94-7-4 WINDNOISE/WATER LEAKS: VEHICLE WEATHERSTRIP UPDATE

WINDNOISE/WATER LEAKS - VEHICLE WEATHERSTRIP UPDATE - IMPROVED SEALING AROUND TOP AND SIDE WINDOW AREAS

Model(s): Lincoln-Mercury: 1991-94 Capri
Bulletin No.: 94-7-4
Date: April 6, 1994

Fig. 1: Latest Level Vehicle Weatherstrips

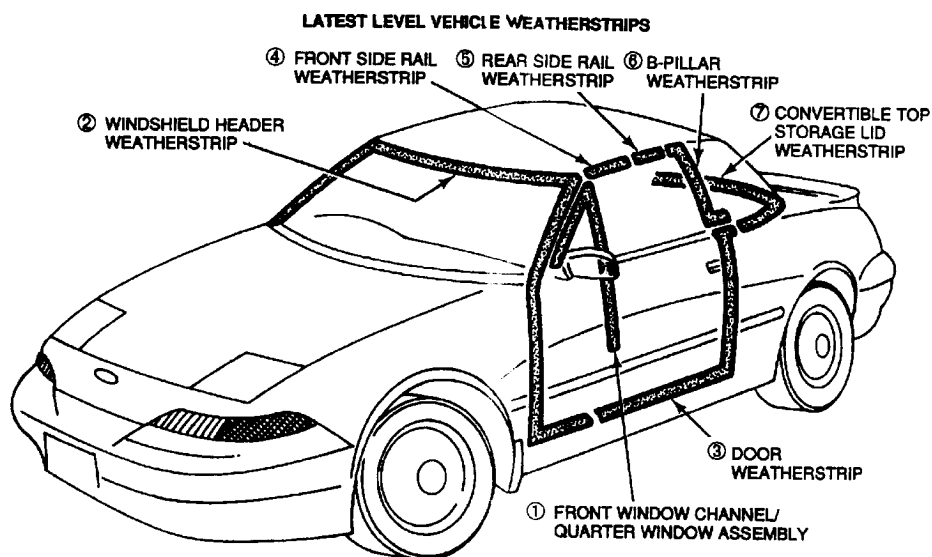
Maximum sealing against water leaks may not be achieved unless the correct level of weatherstrip is fitted to the vehicle.

Refer to Fig. 1 for a diagram and the chart confirming the latest level of weatherstrips, as well as weatherstrip interchangeability across model years. Additional important service literature is also referenced in this TSB article.

- * If an older level front window channel/quarter window assembly requires replacement (i.e. on vehicles built before July 15, 1992), a new windshield header weatherstrip should also be fitted.

NOTE: Glass Adjustment - The fore and aft adjustment setting is 7.0 mm (0.28") for late level front window channel/quarter window assemblies.

- * Refer to TSB 94-7-3 for windshield header weatherstrip replacement procedures on vehicles built before June 1993. Additionally, glass adjustment settings should be checked and adjusted as necessary

QTR WDW ASSY.	F2JY-7621617-C	Y	Y	Y	Y
2. WINDSHIELD HEADER WEATHERSTRIP	F4JY-7651338-A	Y*	Y*	Y*	Y
3. DOOR WEATHERSTRIP	FOJY-7620708-A	Y	Y	Y	N
	FOJY-7620709-A	Y	Y	Y	N
	F2JY-7620708-A	N	N	N	Y
	F2JY-7620709-A	N	N	N	Y
4. FRONT SIDE RAIL WEATHERSTRIP	E9JY-7653986-B	Y	Y	Y**	N
	E9JY-7653987-B	Y	Y	Y**	N
	F2JY-7653986-A	N	N	Y***	Y
	F2JY-7653987-A	N	N	Y***	Y
5. REAR SIDE RAIL WEATHERSTRIP	FOJY-7651566-B	Y	Y	Y**	N
	FOJY-7651567-B	Y	Y	Y**	N
	F2JY-7651566-A	N	N	Y***	Y
	F2JY-7651567-A	N	N	Y***	Y
6. B-PILLAR WEATHERSTRIP	FOJY-7651566-C	Y	Y	Y**	N
	FOJY-7651567-C	Y	Y	Y**	N
	F2JY-7651566-B	N	N	Y***	Y
	F2JY-7651567-B	N	N	Y***	Y
7. CONV. TOP STORAGE	FOJY-76404A06-K	Y	Y	Y	N
	FOJY-76404A06-L	N	N	N	Y

Y* = Y + TSB 94-7-3 and 94-7-4

Y** = Y to 7/92

Y*** = Y from 7/92
